Energy Safe Victoria Validation Report

Powercor 2022–23

Fire Start Report

Final report

Figure 1: Location of 20230209PWA_01 relative to the HBRA/LBRA boundaries in effect prior to 1 November 2021

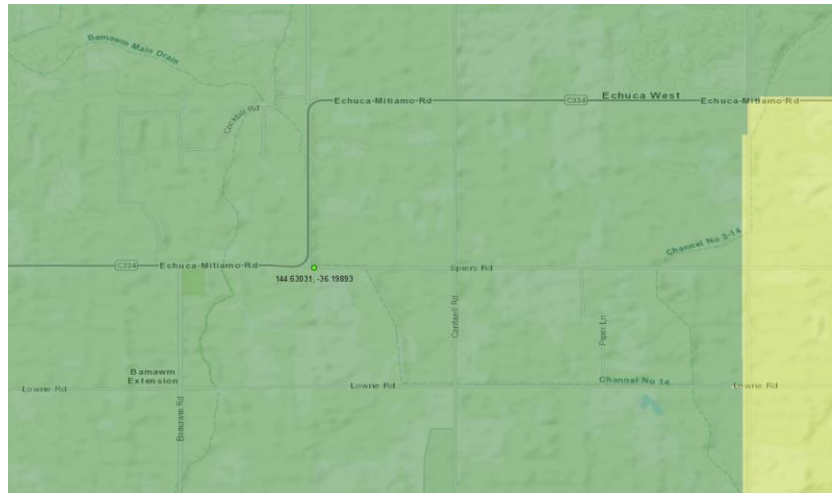
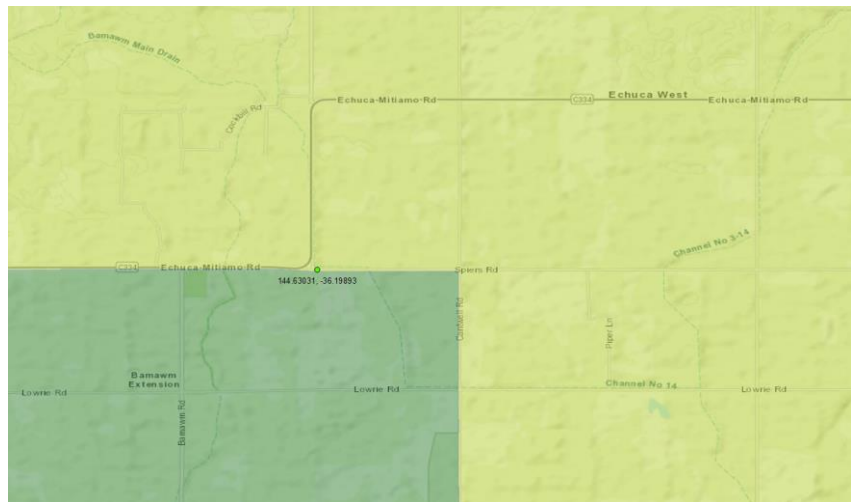
The coordinates listed for incident 20230209PWA_01 were identical in the fire start report and OSIRIS; however, the fire start report recorded this location as being in 'LBRA only' whereas Energy Safe identified it as being in 'HBRA only'. This had a material impact on the IRUs calculated for this incident.

The HBRA and LBRA boundaries for the Powercor network were amended on 1 November 2021. Figure 1 shows the location of incident 20230209PWA_01 within the dark green LBRA zone on the HBRA/LBRA map that applied prior to 1 November 2021. Figure 2 shows the incident location relative to the current HBRA/LBRA boundaries applicable to the Powercor network. While the incident is close to the LBRA layer, it is clearly now located in the light green HBRA layer and, as such, should be designated as 'HBRA only'.

Powercor reviewed the findings of the draft validation report and amended the final Powercor fire start report accordingly.
